# Access Compliance Report

## Public Rights-of-Way

### (Curb Ramps)

Intersection ID: 31403	Main Street: BITTERROOT_CT	Cross Street: BRAWER_FARM_DR	Location: W
ADA ID: 789FCB06905B	Ramp Type: Perp	Initial Pass/Fail: Fail	Overall Compliance: No
Severity Score: 13.75			
Codes/Mitigation Info/Possible Solution		Field Measurements/Component Compliance

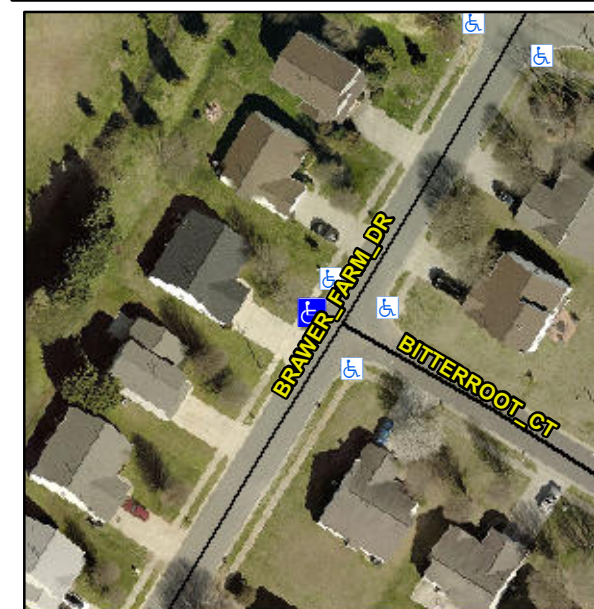
**R304.2.2**

Compliance	Description	Data	Compliance	Description	Data
N/A	Ramp Length (in)	47.5	No	Ramp Slope (%)	8.4
Yes	Ramp Width (in)	60.0	Yes	Ramp XSlope (%)	3.8
N/A	Flare Type LT	N/A	N/A	Flare Type RT	N/A
N/A	Flare Slope LT (%)	N/A	N/A	Flare Slope RT (%)	N/A
N/A	Flare Traversable LT?	N/A	N/A	Flare Traversable RT?	N/A
N/A	Landing Length (in)	N/A	N/A	DWS Provided?	N/A
N/A	Landing Width (in)	N/A	N/A	DWS Contrast?	N/A
N/A	Landing Slope (%)	N/A	N/A	DWS Length (in)	N/A
N/A	Landing X Slope (%)	N/A	N/A	DWS Full Width?	N/A
N/A	Landing Curb? (Y/N)	N/A	N/A	DWS Offset (in)	N/A
N/A	Shared Landing?	N/A			
N/A	Gutter Ponding?	N/A	N/A	Gutter Slope (%)	N/A
N/A	Gutter Lip Ht (in)	N/A	N/A	Gutter X Slope (%)	N/A
N/A	Painted X Walk1?	No	N/A	Painted X Walk2?	N/A
	X Walk 1 Direction	To E		X Walk 2 Direction	N/A
N/A	X Walk 1 Width (in)	N/A	N/A	X Walk 2 Width (in)	N/A
	X Walk 1 Slope (%)	3.7		X Walk 2 Slope (%)	N/A
	X Walk 1 X Slope (%)	3.8		X Walk 2 X Slope (%)	N/A

**Remove & Replace Entire Ramp.**
